Irwin Thomas M2016-0054 TR-1, Answers to CDOT Questions

TO: Colorado Department of Transportation: Tim Bilobran, David Thomas, Steven Heimmer
FROM: Landon Wilhite, Ethan Weichert, JC York Calvin Miller, Barb Brunk Christian Morgan, Barb Brunk
DATE: May 12, 2023
RE: Colorado Department of Transportation (CDOT) questions regarding Colorado Department of Reclamation Mining and Safety (DRMS) Irwin Thomas 112 Permit M2016-054, Technical Revision #1

Figure 9. Model Scenario 5: Drawdown and mounding after completion of mining and site reclamation.

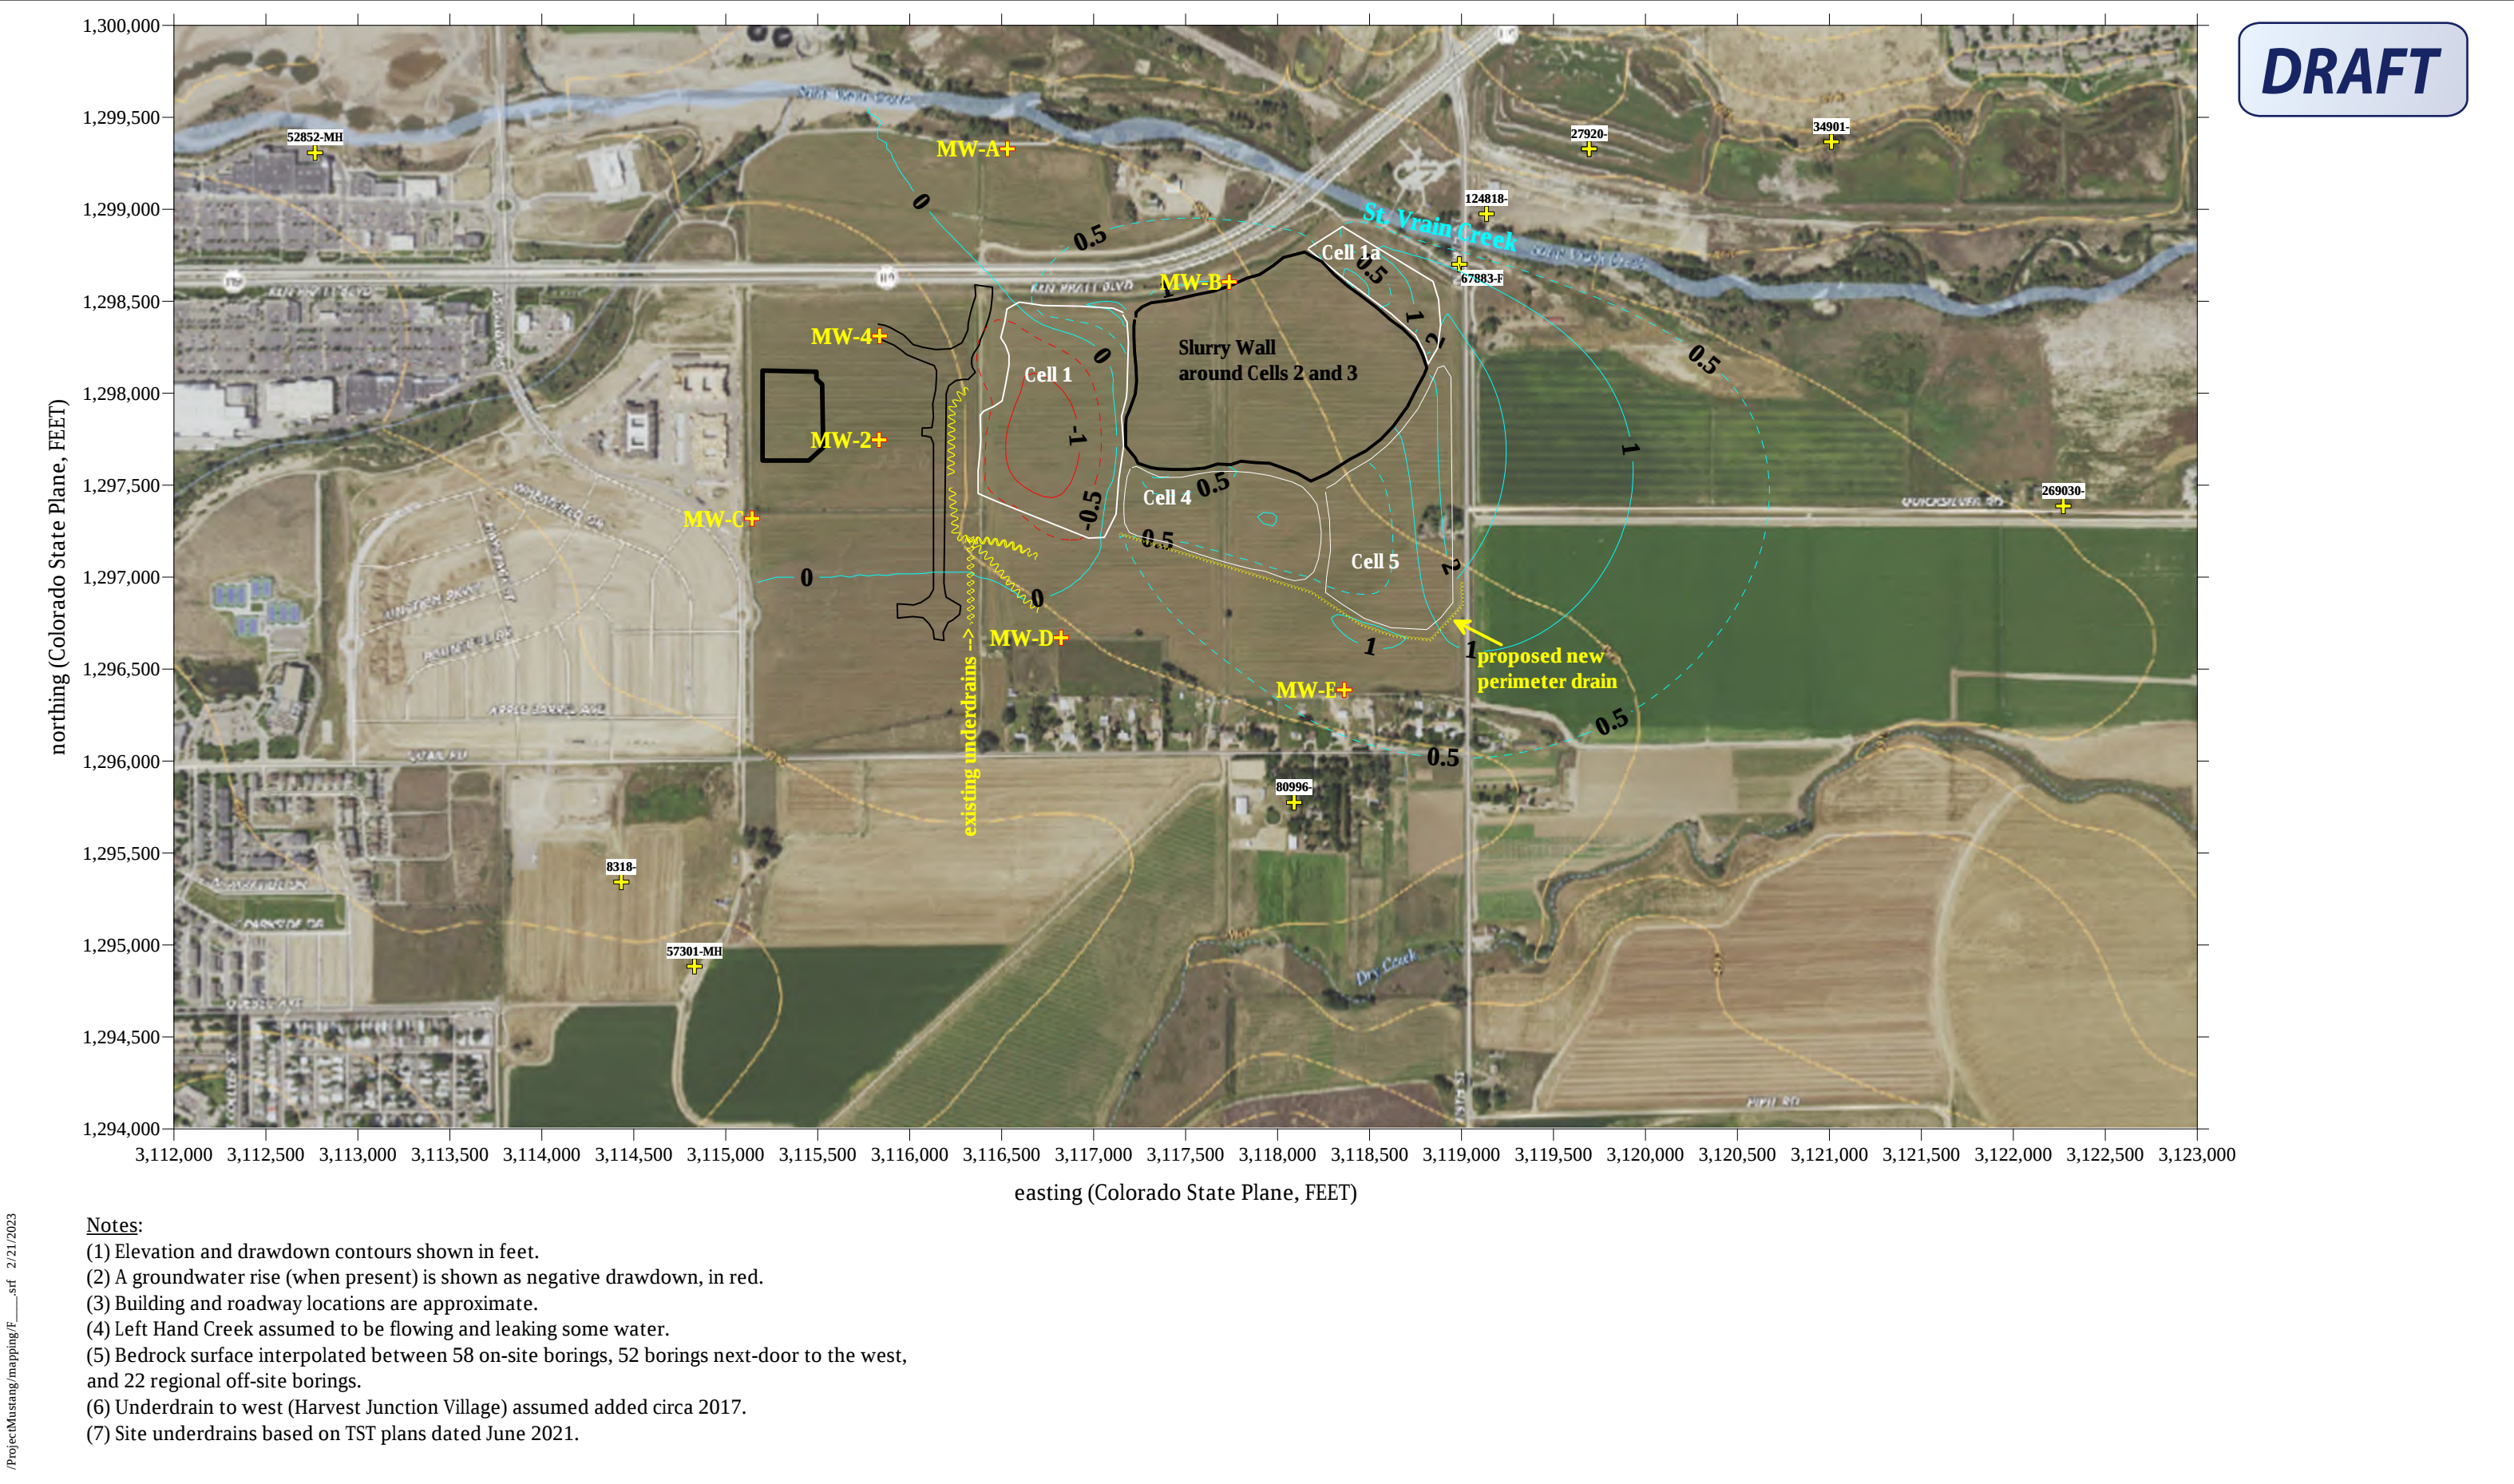
2. They state when they are going to reclaim it, it will become sealed or unlined ponds, what is the long-term effect on HWY 119 if it is saturated due to these ponds.

6. It is assumed groundwater is being pumped. What happens when mining ends and the groundwater rises? ***Applicant Response: Impacts on water levels are shown on Figures 8 and 9 of the Groundwater Evaluation. Water level under HWY ROW will be drawn down 0 to 1 foot during mining (Figure 8) and 0 to .5 feet (Figure 9) when reclamation is complete. No mounding under the HWY ROW was identified in the model. Following our discussion, Miller Groundwater Engineering prepared the attached letter dated April 13, 2023 to further clarify anticipated impacts to groundwater under HWY 119 adjacent to the mine.***

will be drawn down 0 to 1 foot during mining (Figure 8) and 0 to .5 feet (Figure 9) when mining is complete. No mounding under the HWY ROW is identified in the model.

Applicant Response: *The attached Groundwater Analysis prepared by Miller Groundwater Engineering, for the south side of the HWY, demonstrates impact to the water table with Mining and Reclamation, including installation of the slurry wall. The highway now sits on top of existing groundwater (see Figure 5 in the Model – existing water table is between 10 and 20' deep under the HWY ROW). Impacts on water levels are shown on Figures 8 and 9. The water level under HWY 119 ROW will be drawn down 0 to 1 foot during mining (Figure 8) and 0 to .5 feet (Figure 9) when mining is complete. No mounding under the HWY ROW is identified in the model. Following our discussion, Miller Groundwater Engineering prepared the attached letter dated April 13, 2023 to further clarify anticipated impacts to groundwater under HWY 119 adjacent to the mine.*
